GC Services for UK King's Daughters Medical Center – Greenup Co. Urgent Care/Family Care Medical Office Building

ADDENDUM # 01

GREENUP COUNTY URGENT CARE / FAMILY CARE MEDICAL OFFICE BUILDING

The Addendum will form a part of the Proposal Documents and modifies the original Proposal Documents dated May 1, 2026.

CALLOUT PLAN - AREA B
A-112
COPYRIGHT 2026 - JRA, INC.

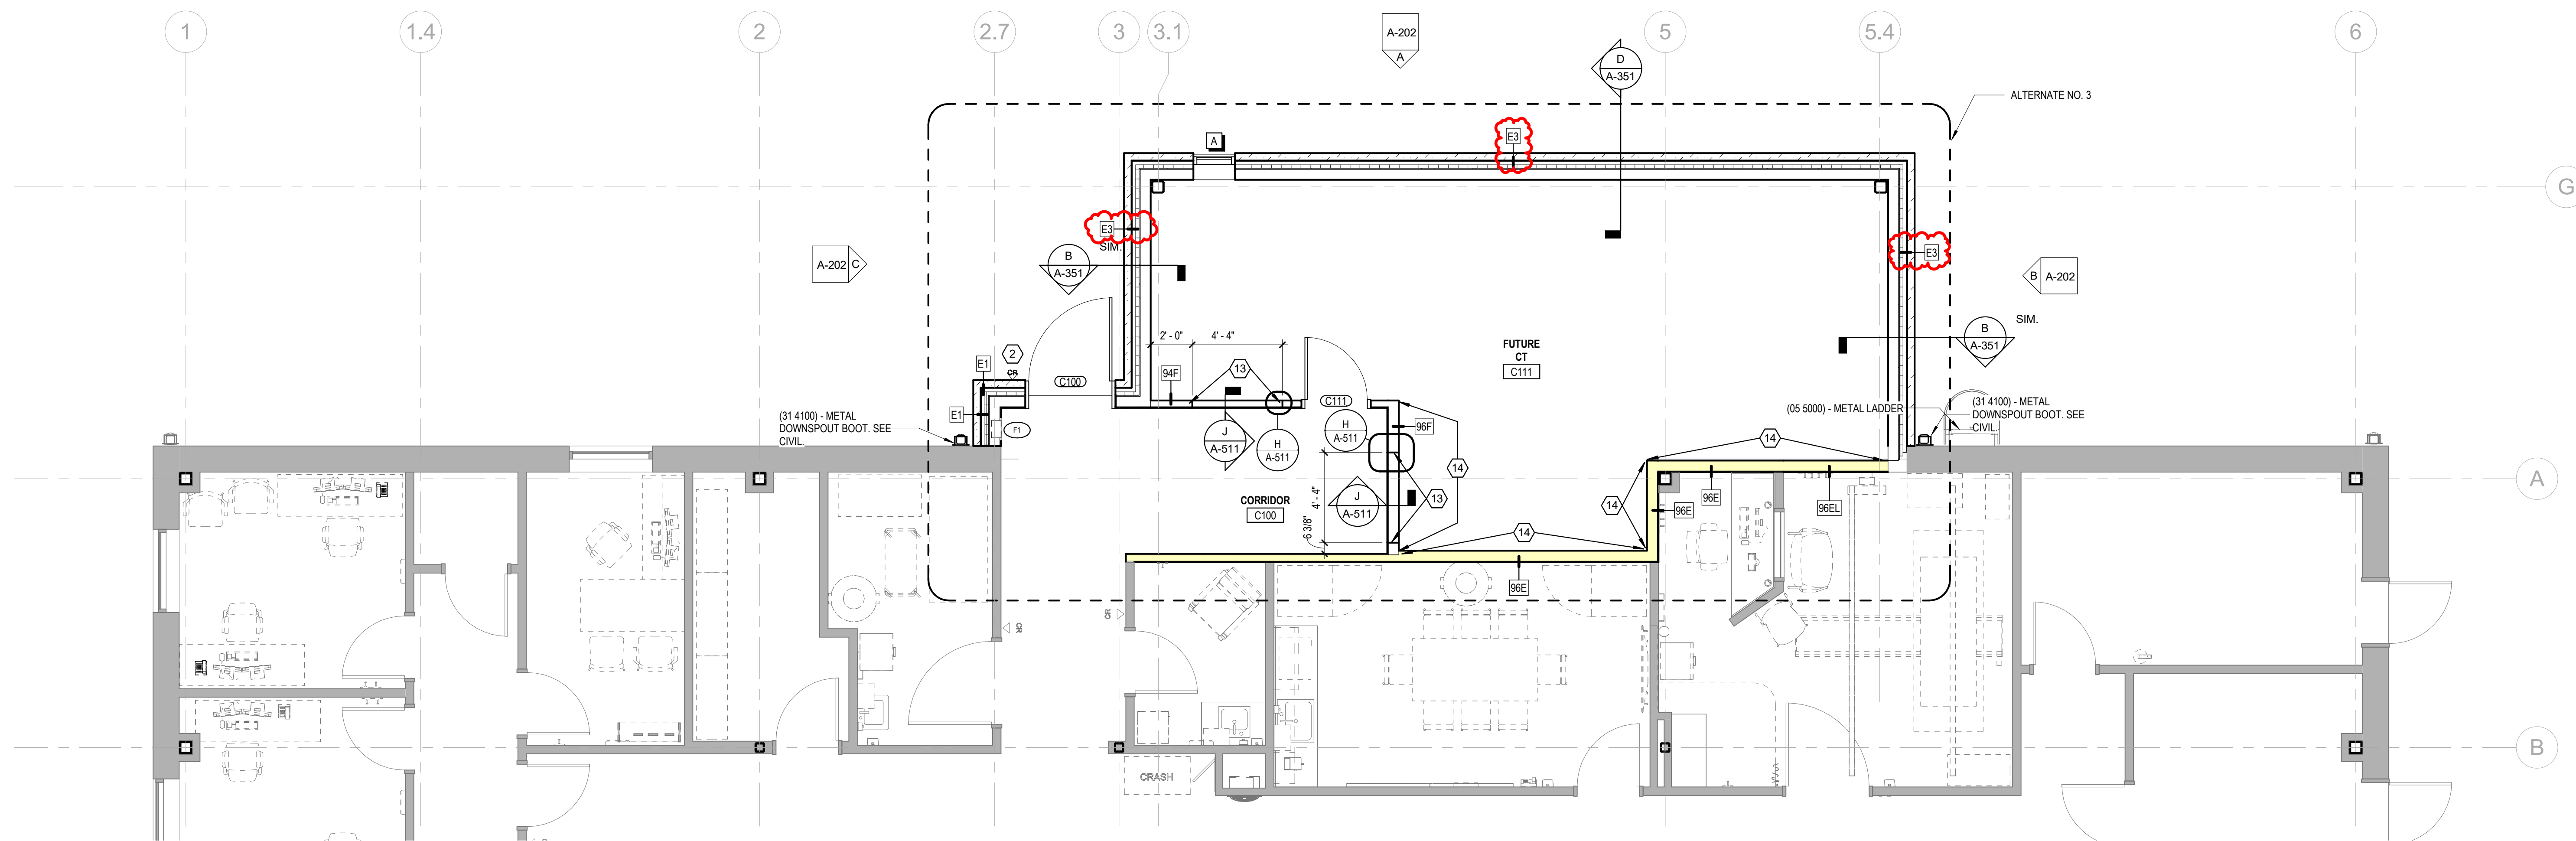
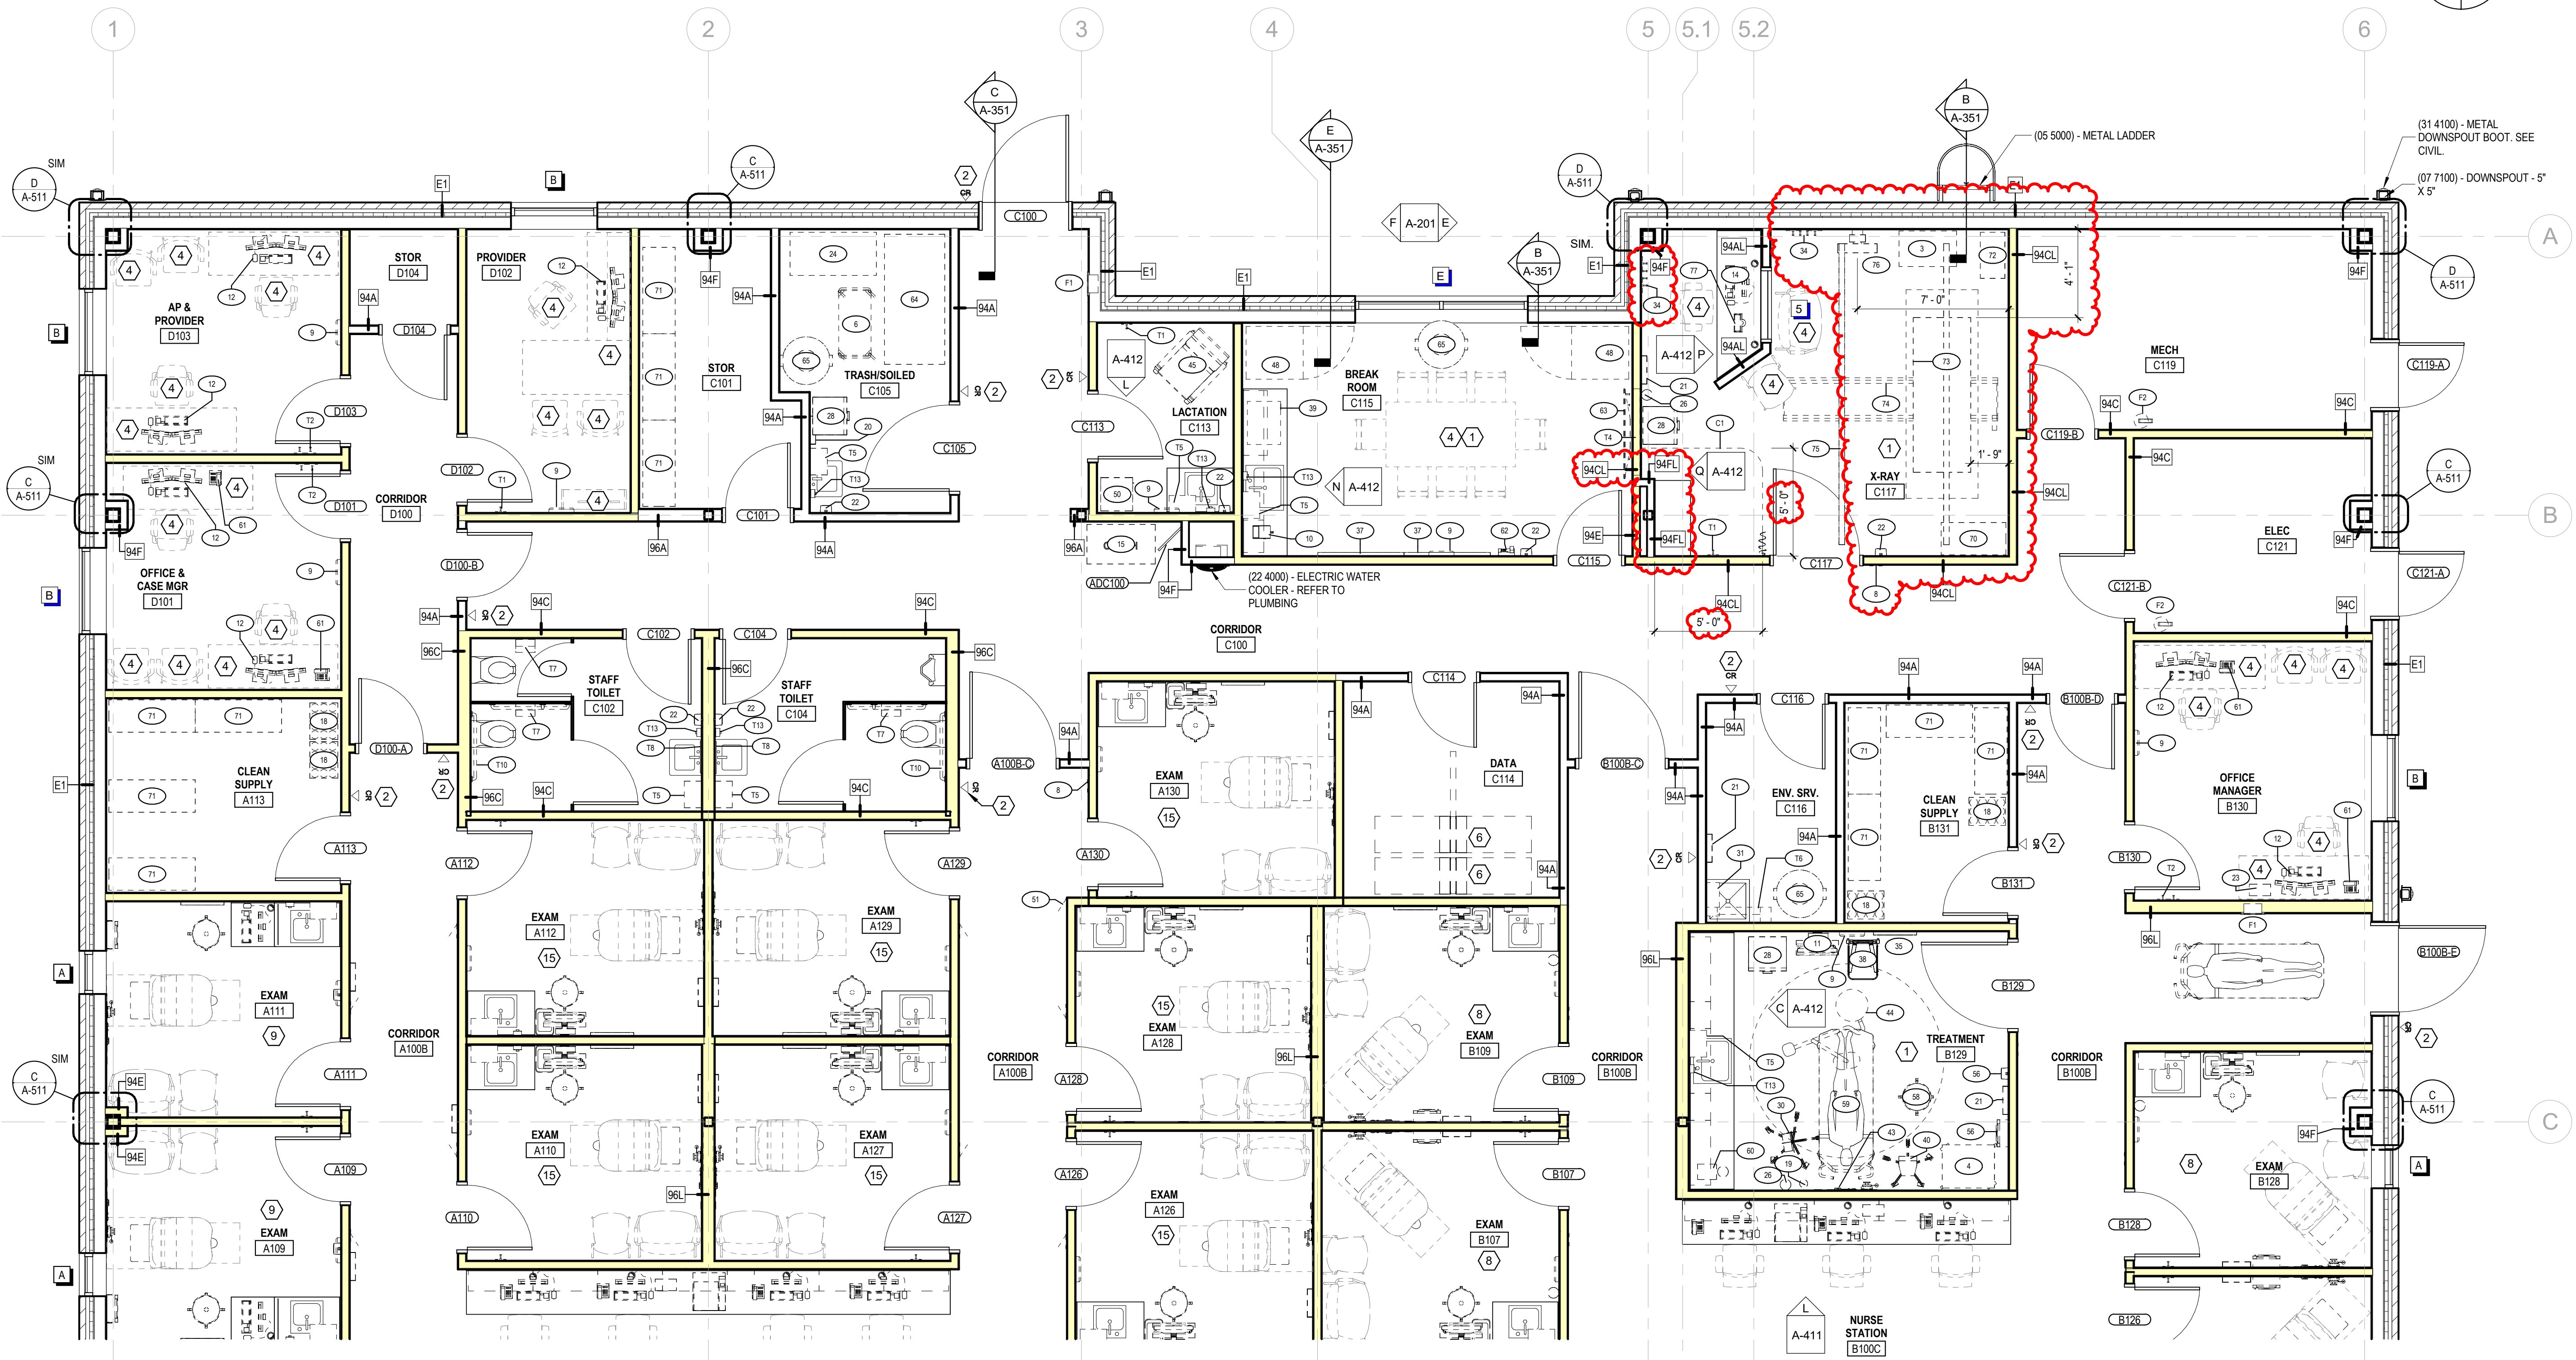
Clarification: for Alternate No. 3, no drywall will be applied to the exterior and interior studs on the Future CT C111 room side. Refer to the attached revised Sheets A-112 and A-501 for revised wall types and callouts to reflect this intent.

Refer to the attached revised Sheet A-112 for revised equipment location in X-ray C117, as well as revised partition types coordinating to the radiation shielding revision.

DOOR TYPES
1/4" = 1'-0"

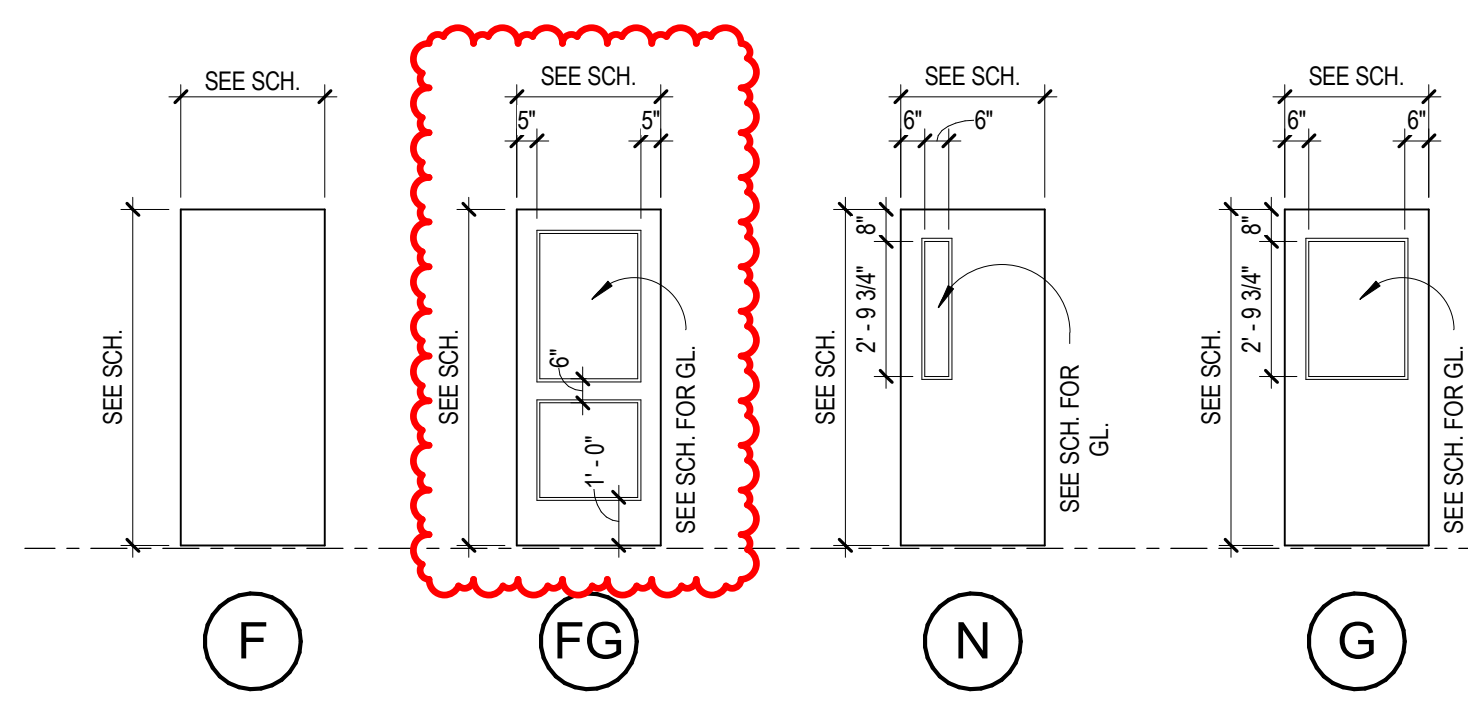
Refer to the Door Types. Revise Type FG as indicated on the attached revised Sheet A-601.
